SCHIRMER ENGINEERING CORPORATION  
707 LAKE COOK ROAD  
DEERFIELD, ILLINOIS 60015  
(312) 272-8340

ANALYSIS OF FIRE DETECTOR LOCATIONS  
AT  
LASALLE COUNTY STATION  
FOR  
SARGENT & LUNDY ENGINEERS  
AND  
COMMONWEALTH EDISON COMPANY

May 14, 1984

7B1-3

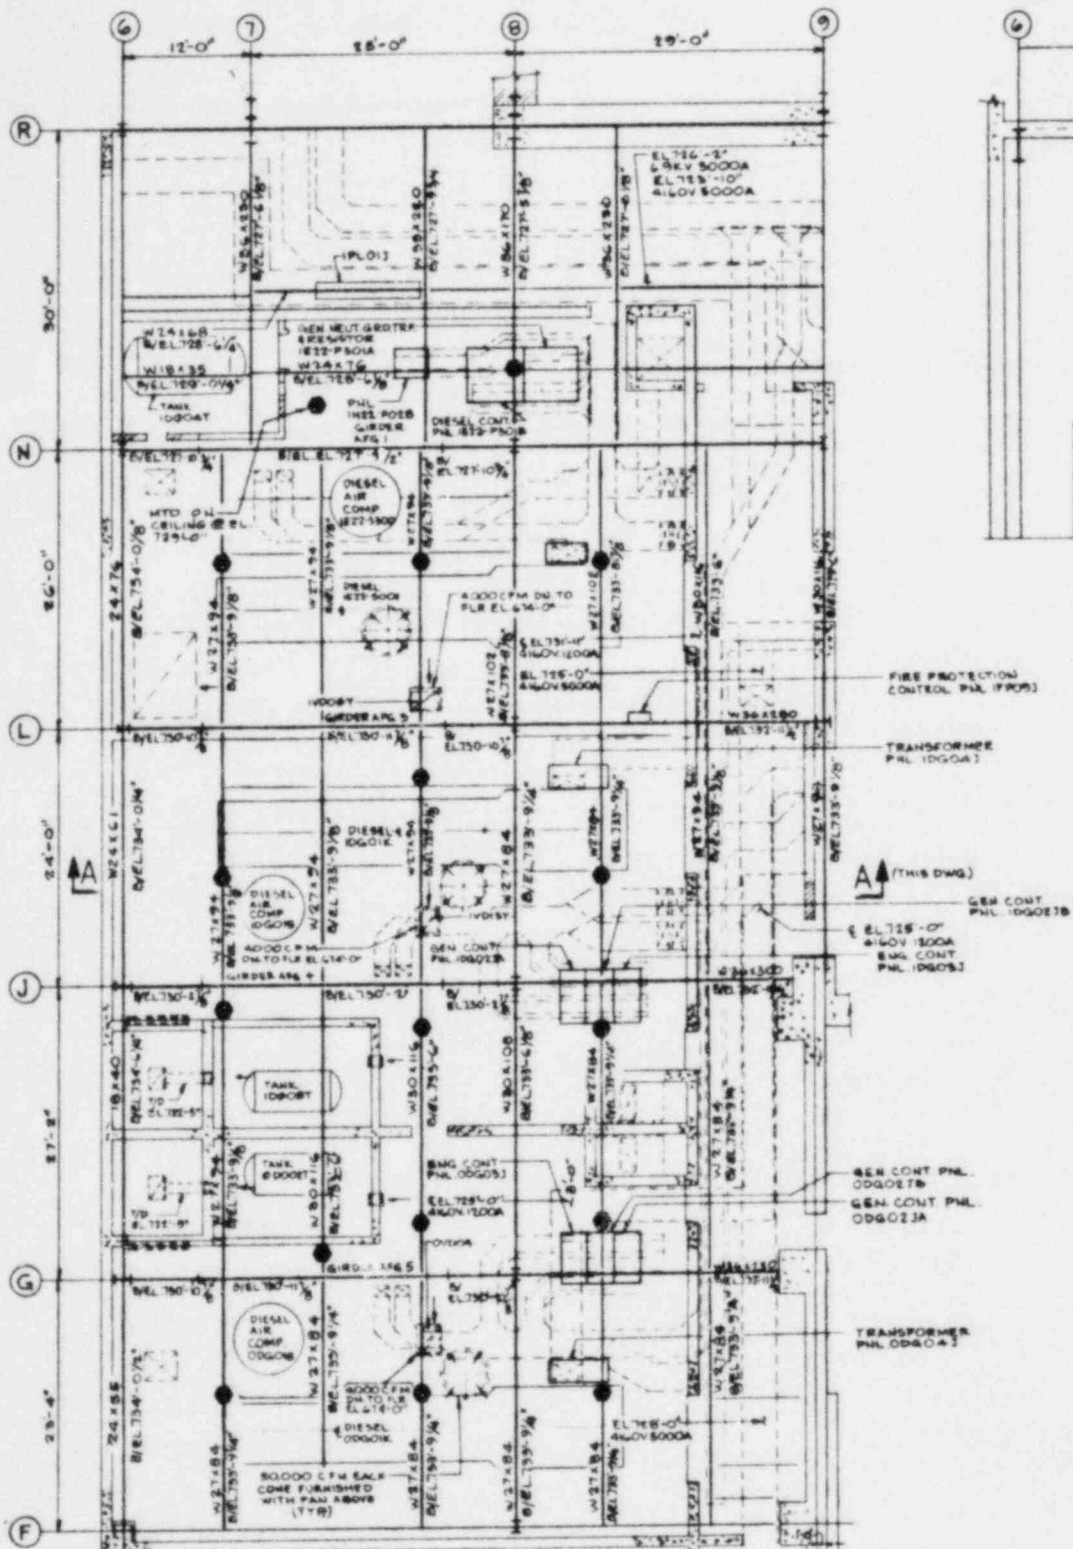
The sensitivity of a detector will be lessened in a high ceiling area. NFPA 72E has recognized this and recommends a listed spacing of 46 percent when ceiling heights are between 24 and 26 feet. With this reduction, the installed detector spacing exceeds the adjusted listed spacing. Also, detectors have been located over the generator. The generator occupies one-half of the room and, as such, detectors are spaced too far from the opposite wall.

The room is subdivided by a deep beam running north and south. Five additional 27-inch deep beams further subdivide the ceiling of the zone into bays. According to NFPA 72E, detectors would normally be required in each bay, thereby requiring an additional 12 detectors. However, because of the height of the ceiling (see above discussion) and the possibility of heat rising and filling the bays when the generator is running (e.g., a normal operation or maintenance run), it is recommended that detectors be located at the bottom of alternate W27 beams on the east side of the north/south beam. In this way, the beam flange will serve as the heat collector while mounting detectors some distance below the ceiling will lessen the possibility of a false trip. On the west side of the north/south beam, the ceiling height is lower. Due to the reduced ceiling height, two detectors should be installed in this area.

This design would require a total of 5 detectors. The two detectors that are already installed may be relocated, thereby requiring the addition of three new  $190^{\circ}\text{F} \pm 10^{\circ}\text{F}$  heat detectors. These detectors should be installed as indicated on Drawing 7B1-3. All heat detectors should serve to actuate the CO<sub>2</sub> system. By doing this, the average area per detector will be 374 square feet, which is within the NFPA 72E guidelines for a high ceiling area.

The sensitivity of a detector will be lessened in a high ceiling area. NFPA 72E has recognized this and recommends a listed spacing of 46 percent when ceiling heights are between 24 and 26 feet. With this reduction, the installed detector spacing exceeds the adjusted listed spacing. Also, detectors have been located over the generator. The generator occupies one-half of the room and, as such, detectors are spaced too far from the opposite wall.

The room is subdivided by a deep beam running north and south. Five additional 27-inch deep beams further subdivide the ceiling of the zone into bays. According to NFPA 72E, detectors would normally be required in each bay, thereby requiring an additional 12 detectors. However, because of the height of the ceiling (see above discussion) and the possibility of heat rising and filling the bays when the generator is running (e.g., a normal operation or maintenance run), it is recommended that detectors, for the most part, be located at the bottom of alternate deep beams on each side of the north/south beam. In this way, the beam flange will serve as the heat collector while mounting detectors some distance below the ceiling will lessen the possibility of a false trip.

This design would require a total of 6 detectors. The two detectors that are already installed may be relocated, thereby requiring the addition of four new 190°F  $\pm$  10°F heat detectors. These detectors should be installed as indicated on Drawing 7B1-3. All heat detectors should serve to actuate the CO<sub>2</sub> system. By doing this, the average area per detector will be 277 square feet, which is within the NFPA 72E guidelines for a high ceiling area.

The sensitivity of a detector will be lessened in a high ceiling area. NFPA 72E has recognized this and recommends a listed spacing of 46 percent when ceiling heights are between 24 and 26 feet. With this reduction, the installed detector spacing exceeds the adjusted listed spacing. Also, detectors have been located over the generator. The generator occupies one-half of the room and, as such, detectors are spaced too far from the opposite wall.

The room is subdivided by a deep beam running north and south. Five additional 27-inch deep beams further subdivide the ceiling of the zone into bays. According to NFPA 72E, detectors would normally be required in each bay, thereby requiring an additional 12 detectors. However, because of the height of the ceiling (see above discussion) and the possibility of heat rising and filling the bays when the generator is running (e.g., a normal operation or maintenance run), it is recommended that detectors, for the most part, be located at the bottom of alternate deep beams on each side of the north/south beam. In this way, the beam flange will serve as the heat collector while mounting detectors some distance below the ceiling will lessen the possibility of a false trip.

This design would require a total of 6 detectors. The two detectors that are already installed may be relocated, thereby requiring the addition of four new 190°F  $\pm$  10°F heat detectors. These detectors should be installed as indicated on Drawing 7B1-3. All heat detectors should serve to actuate the CO<sub>2</sub> system. By doing this, the average area per detector will be 289 square feet, which is within the NFPA 72E guidelines for a high ceiling area.

UNIT-2  
DIESEL GENERATOR ROOM  
PLAN EL. 710'-6"  
FIRE ZONE 8B1-2

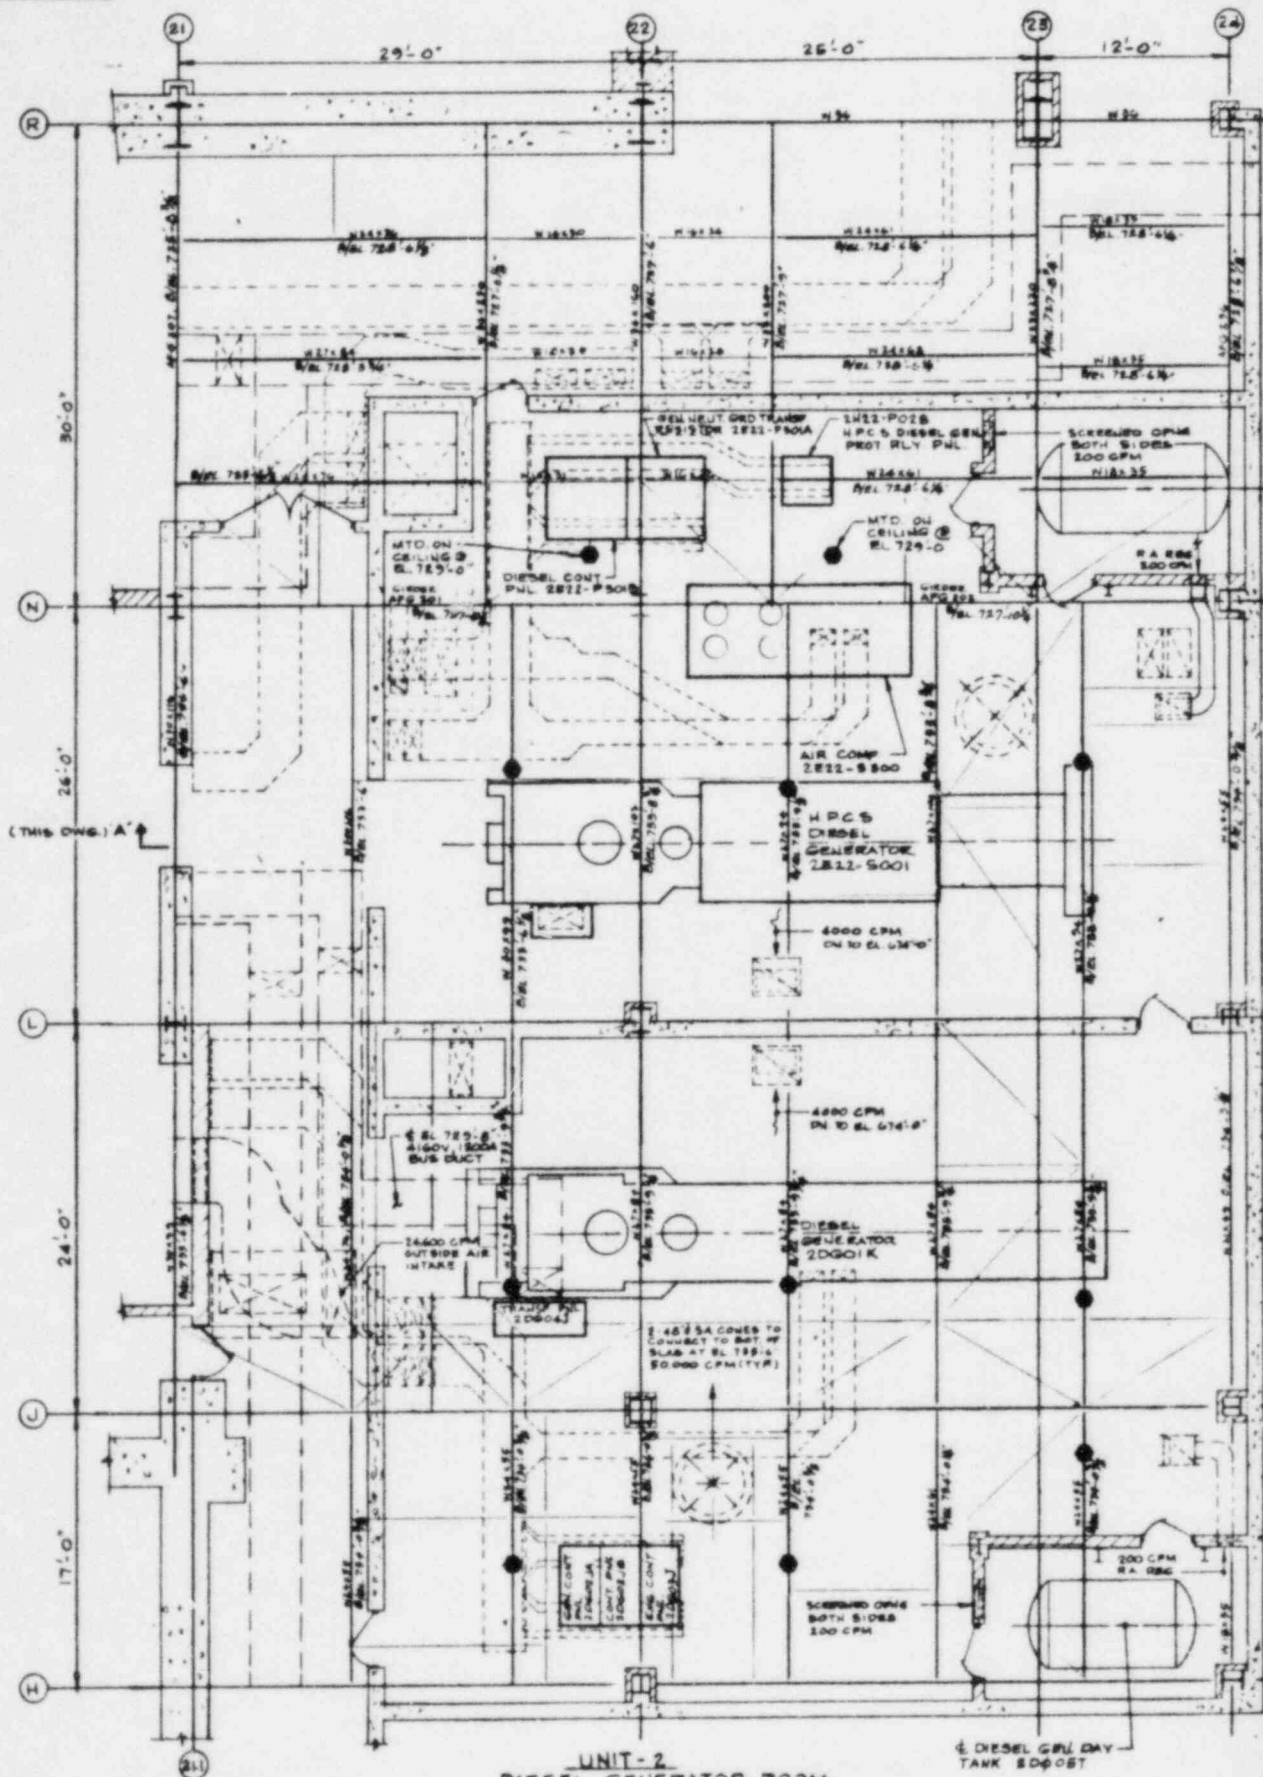
The sensitivity of a detector will be lessened in a high ceiling area. NFPA 72E has recognized this and recommends a listed spacing of 46 percent when ceiling heights are between 24 and 26 feet. With this reduction, the installed detector spacing exceeds the adjusted listed spacing. Also, detectors have been located over the generator. The generator occupies one-half of the room and, as such, detectors are spaced too far from the opposite wall.

The room is subdivided by a deep beam running north and south. Five additional 27-inch deep beams further subdivide the ceiling of the zone into bays. According to NFPA 72E, detectors would normally be required in each bay, thereby requiring an additional 12 detectors. However, because of the height of the ceiling (see above discussion) and the possibility of heat rising and filling the bays when the generator is running (e.g., a normal operation or maintenance run), it is recommended that detectors be located at the bottom of alternate W27 beams on the east side of the north/south beam. In this way, the beam flange will serve as the heat collector while mounting detectors some distance below the ceiling will lessen the possibility of a false trip. On the west side of the north/south beam, the ceiling height is lower. Due to the reduced ceiling height, two detectors should be installed in this area.

This design would require a total of 5 detectors. The two detectors that are already installed may be relocated, thereby requiring the addition of three new 190°F  $\pm$  10°F heat detectors. These detectors should be installed as indicated on Drawing 8B1-2. All heat detectors should serve to actuate the CO<sub>2</sub> system. By doing this, the average area per detector will be 374 square feet, which is within the NFPA 72E guidelines for a high ceiling area.

The room is subdivided by a deep beam running north and south. Five additional 27-inch deep beams further subdivide the ceiling of the zone into bays. Detectors would normally be required in each bay, thereby requiring an additional 12 detectors. However, due to the potential for activation by a heat buildup in the bays while the generator is running (e.g., a maintenance run), it is recommended that detectors, for the most part, be located at the bottom of alternate deep beams on each side of the north/south beam. In this way, the beam flange will serve as the heat collector while mounting detectors some distance below the ceiling will lessen the possibility of a false trip.

This design would require a total of 6 detectors. The two detectors that are already installed may be relocated, thereby requiring the addition of four new detectors. These detectors should be installed as indicated on Drawing 8B1-2. All heat detectors should serve to actuate the CO<sub>2</sub> system. By doing this, the average area per detector will be 334 square feet, which is within NFPA 72E guidelines for a high ceiling area.
